Proposed Response to Environmental Impact Assessment Scoping Report

Lower Thames Crossing Task Force

20 November 2017

Lower Thames Crossing Preferred Route

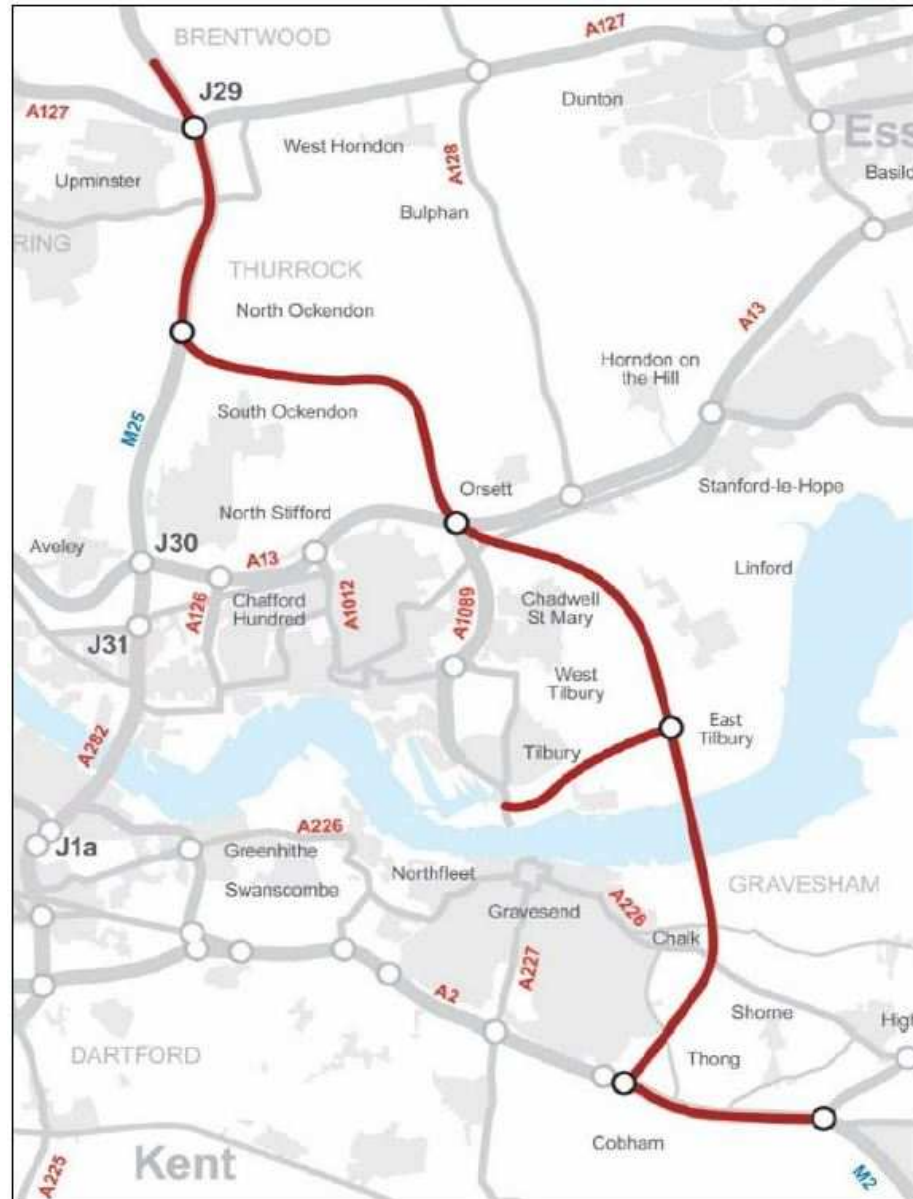
- The Council has major concerns regarding the proposed junction with the A13 and A1089
 - Will be significantly elevated, therefore will be prominent in the landscape and likely to also cause adverse visual effects
 - Likely to worsen air quality and increase noise for receptors close by
 - Located on a nationally significant Scheduled Monument (Cropmark Complex, Orsett)
